Modification Recommended Service Note

T1250A-04

T1250A Smart RF Switching Unit

Original Manu-D cable vs new Conquest cable

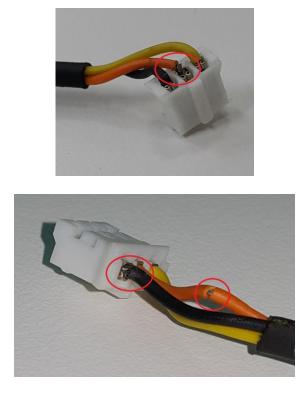
Failure analysis revealed a quality issue with the original control cables and DC power cables, as shown in the pictures below:

Cables crimping poor quality was the identified root cause.

Cable vendor was changed to ensure cables meet the quality standards (part numbers remained the same). The following picture shows an example of original cable, and new cable:

• New units: this cable vendor change was implemented in Production starting with serial number MY54050143.

Installed base: any T1250A returned to Factory for service (this model is supported Return to Factory) since October 2015 has been reworked to replace the original control and DC cables with new vendor cables.
